RESPONSE TO USEPA STATEMENT OF POSITION

Phoenix-Goodyear Airport-North Superfund Site
Goodyear, Arizona

Submitted By: AMEC Geomatrix, Inc.
Scottsdale, Arizona

Date: October 25, 2010

Observation Wells Response to Injection, IA-11 Area and
IA-12 Area

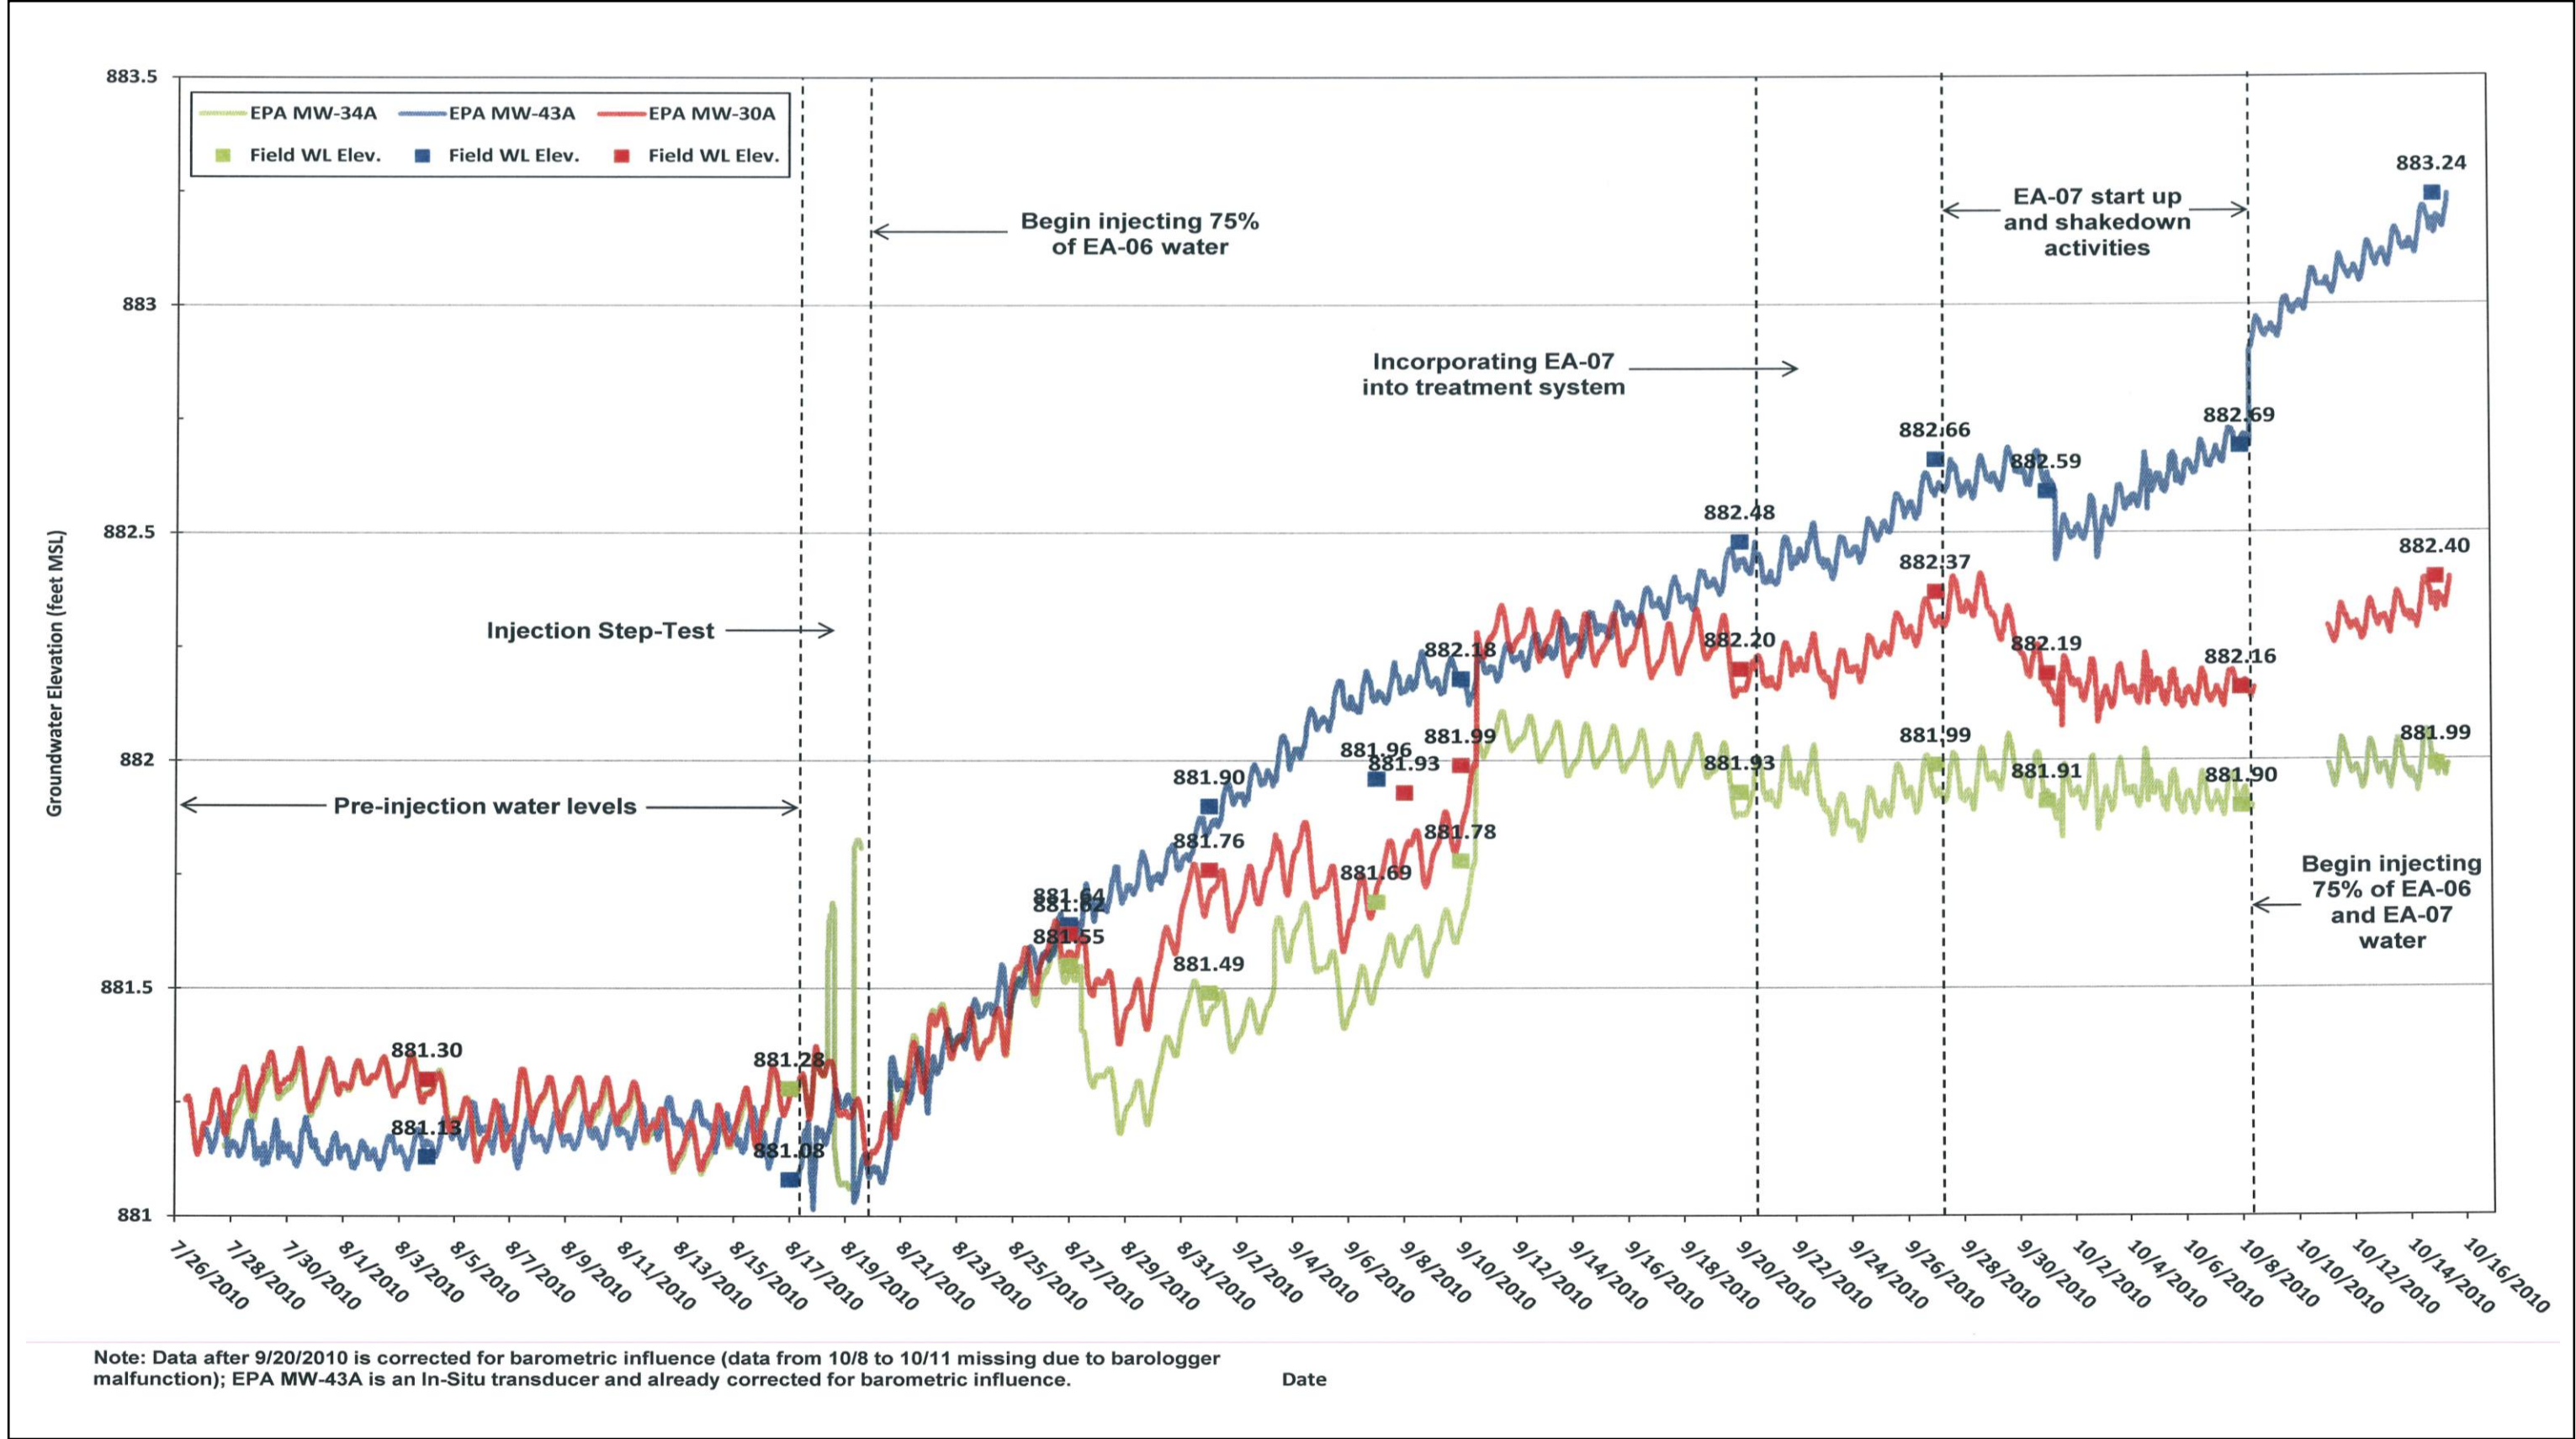
- Hand-measured water level data show that water levels in EPA MW-39A (Attachment A1) started to indicate a discernable influence from injection of groundwater on approximately August 27, 2010 (884.30 ft amsl), with an increase of 0.40 feet over pre-injection conditions.

- Hand-measured water level data show that water levels in EPA MW-55A (Attachment A1) started to indicate a discernable influence from injection of groundwater on approximately September 20, 2010 (883.28 ft amsl), with an increase of 0.53 feet over pre-injection conditions.

- Hand-measured water level data show that water levels in EPA MW-30A (Attachment A2) started to indicate a discernable influence from injection of groundwater on approximately September 1, 2010 (881.76 ft amsl), with an increase of 0.46 feet over pre-injection conditions.

- Hand-measured water level data show that water levels in EPA MW-34A (Attachment A2) started to indicate a discernable influence from injection of groundwater on approximately September 7, 2010 (881.69 ft amsl), with an increase of 0.41 feet over pre-injection conditions.

USEPA's Statement of Position states on page 7: "Although groundwater levels in the 3 eastern monitoring wells (MW-35A, MW-45A, and MW-39A) peaked in early summer 2010, they have steadily decreased since July 2010, indicating that the northwest shift in groundwater flow is likely temporary." While it is true that water levels in these wells peaked in June 2010 and declined through August 2010, since the injection of groundwater commenced at IA-11 and IA-12, water levels in these wells have steadily increased, as indicated by the hand-measured water levels and hydrograph presented in Attachment A1.

Groundwater Velocity Observations and Calculations from
Injection Wells IA-11 and IA-12

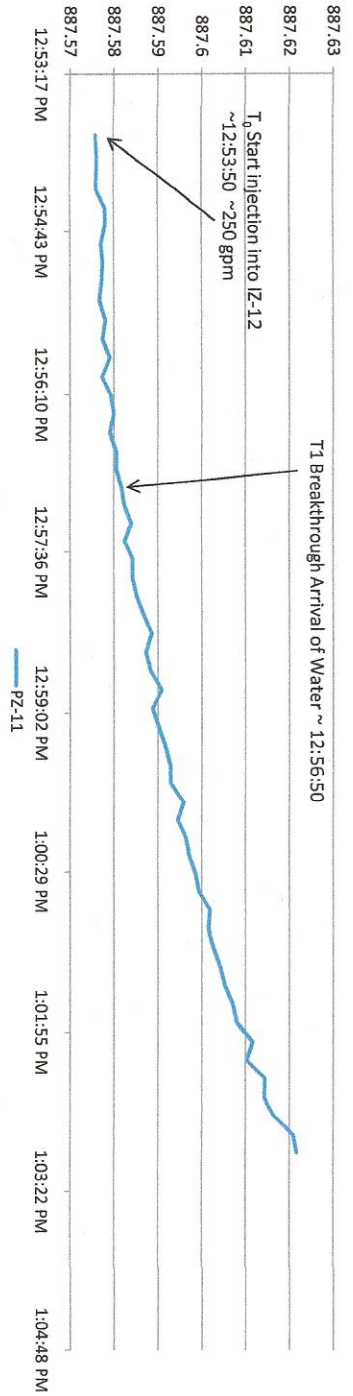
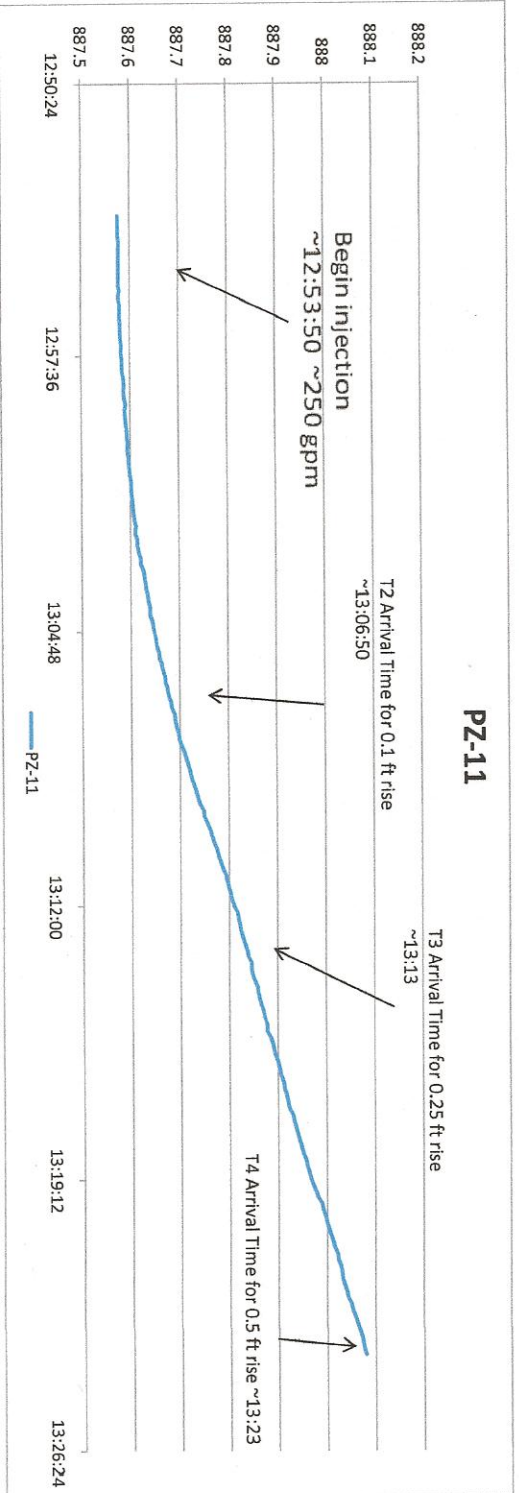
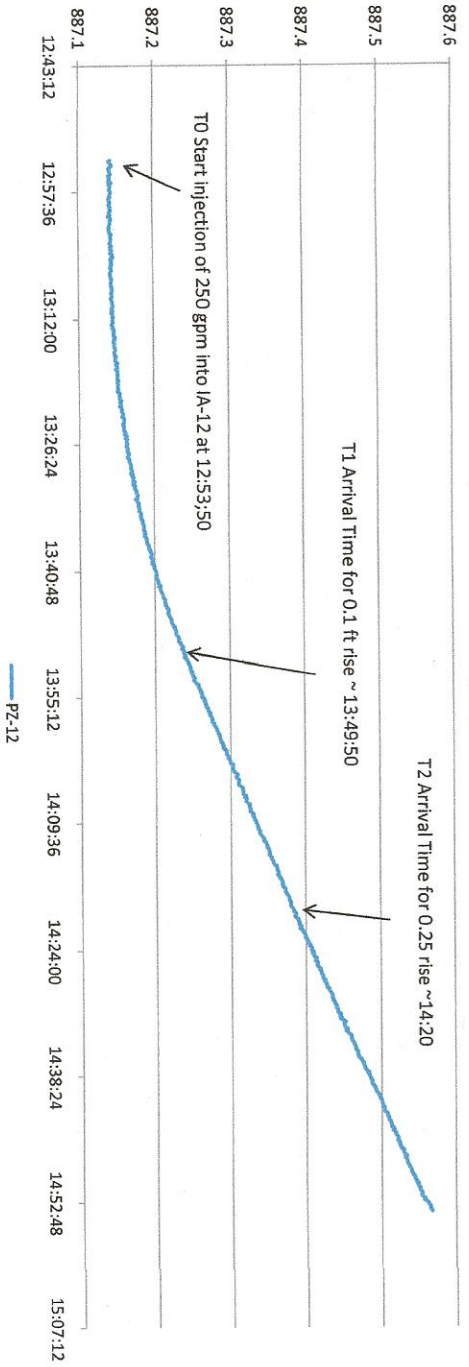
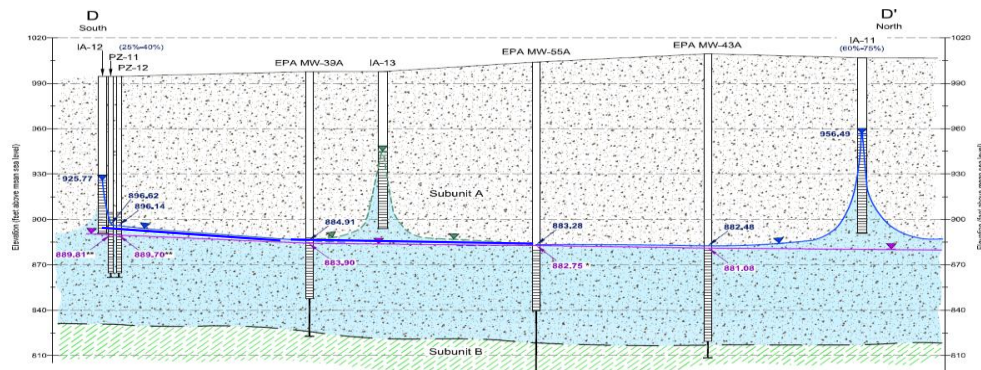
For the observed arrival times at PZ-11 and PZ-12, the following was evaluated 1) the time it took for the initial deflection of the hydrograph, 2) the time it took for an increase of 0.1 feet (ft) to occur, 3) the time it took for an increase of 0.25 ft to occur, and 4) the time it took for an increase of 0.5 ft to occur. The attached graphs show the following;

- The initial deflection of water levels in PZ-11 occurred 3 minutes after injection began.
- Water level increases of 0.1 ft, 0.25 ft, and 0.5 ft occurred 13 minutes, 27 minutes, and 30 minutes, respectively, after injection began. This equates to average linear velocities of 1,584 ft/day to 8,196 ft/day.
- In PZ-12 water level increases of 0.1 ft and 0.25 ft occurred at 56 minutes and 86 minutes, respectively. This equates to average linear velocities of 1,239 ft/day and 1,902 ft/day, respectively.
